Re: **Village at Grafton Woods**
Response to Traffic Impact Study Peer Review Comments

Tighe & Bond expects to receive supplemental Peer Review Comments from MDM Transportation Consultants, Inc. (MDM), on June 28, 2021. The peer review comments apply to the Traffic Impact and Access Study (TIAS), dated April 2021 and Response to Traffic Impact Study Peer Review Comments, dated May 28, 2021, prepared for the Village at Grafton Woods Development. The following comments were provided to us via email on June 14, 2021, and we understand they are the outstanding comments relative to the Traffic Impact Study. The following presents our response to those concerns.

FIGURE 19

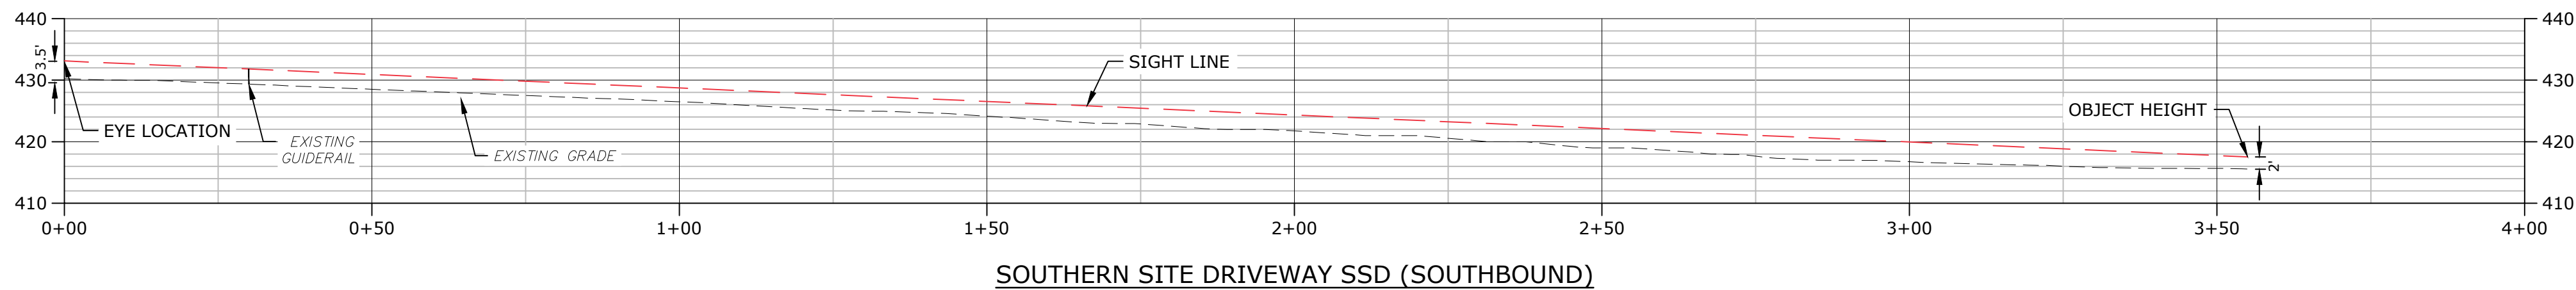
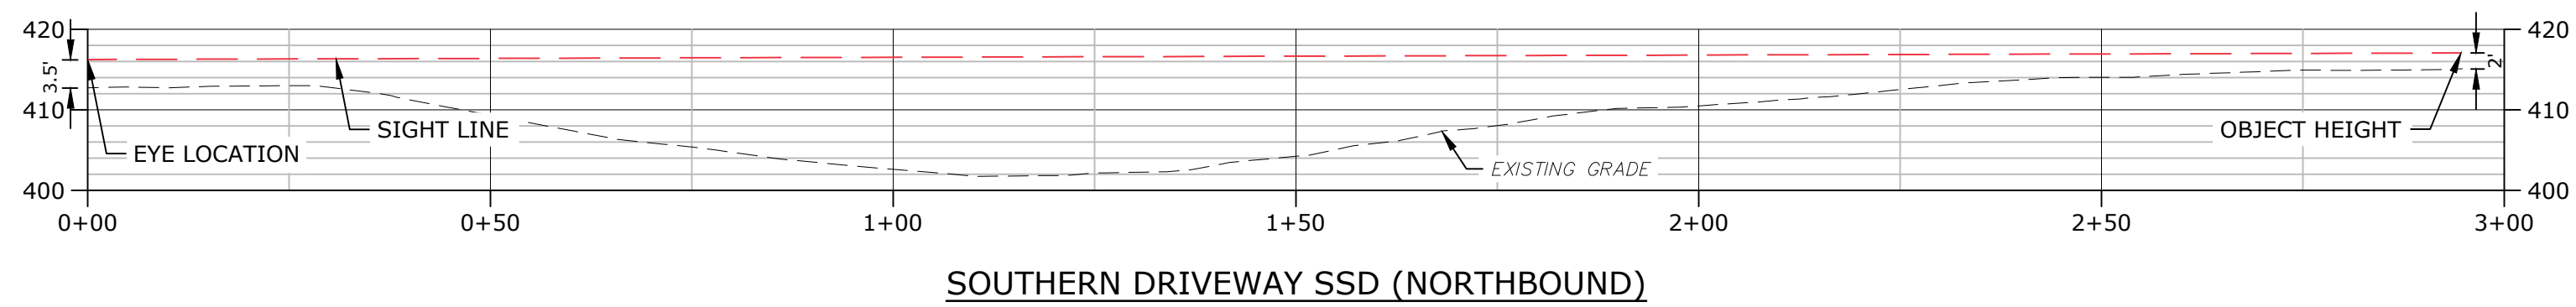
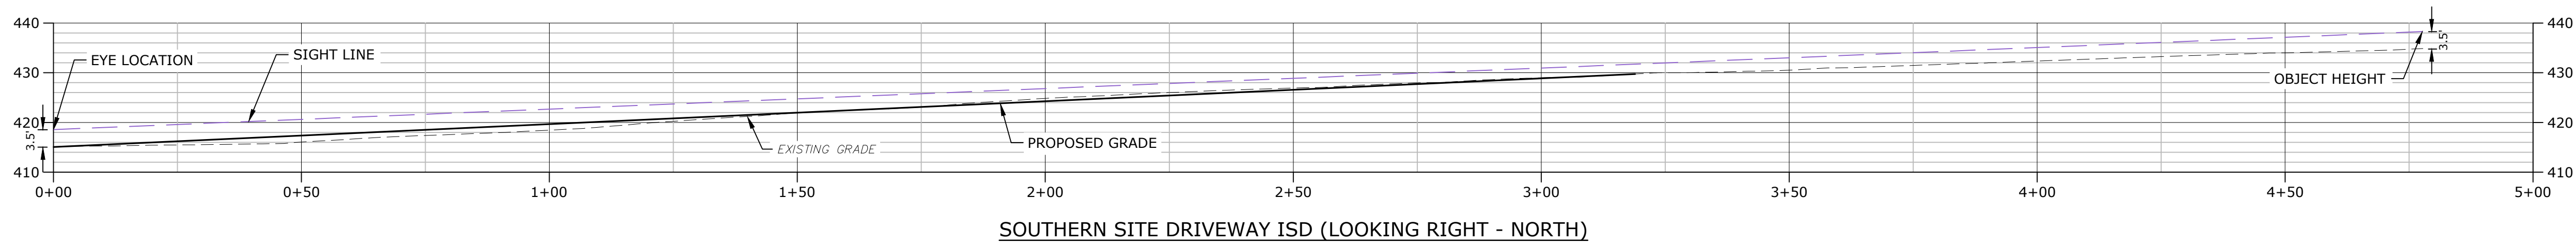
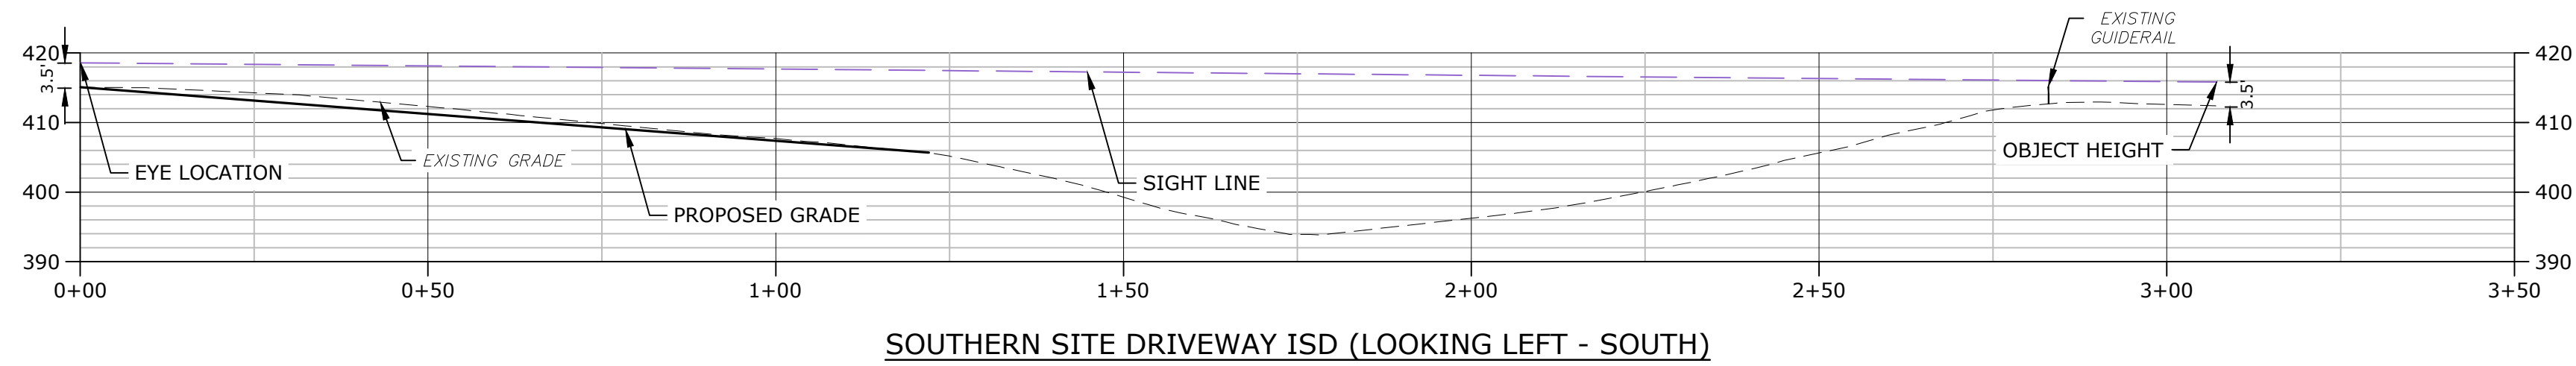
Comment: *Sight lines looking south from the southerly driveway cross over a "no disturb" zone within which trees/vegetation exists or has potential to grow over time and impede sight lines. Likewise, it is unclear whether the guard rail elevation along the east side of Pine Street which may exceed 2 feet in height above roadway grade remains a potential visual obstruction to an object 2 feet above grade at the ped crossing and driveway location. Accordingly, MDM advises that the Site Plans as stamped by a professional engineer depict the sight line triangles at each driveway with a note that acknowledges compliance with applicable sight line criteria within these sight line triangles following AASHTO guidance, with a provision for clearing/maintenance of vegetation or modification of guardrail as required will be conducted to ensure applicable*

sight line criteria are met. Applicant should clarify to what extent clearing/maintenance of vegetation within the "no disturb" zone is feasible should such clearing/maintenance be necessary.

The approximate location of the existing guiderail is now shown on the sight distance profiles at the southern driveway (Figure 19). As shown in the figure, the guiderail is not expected to impact either the available intersection and stopping sight distances.
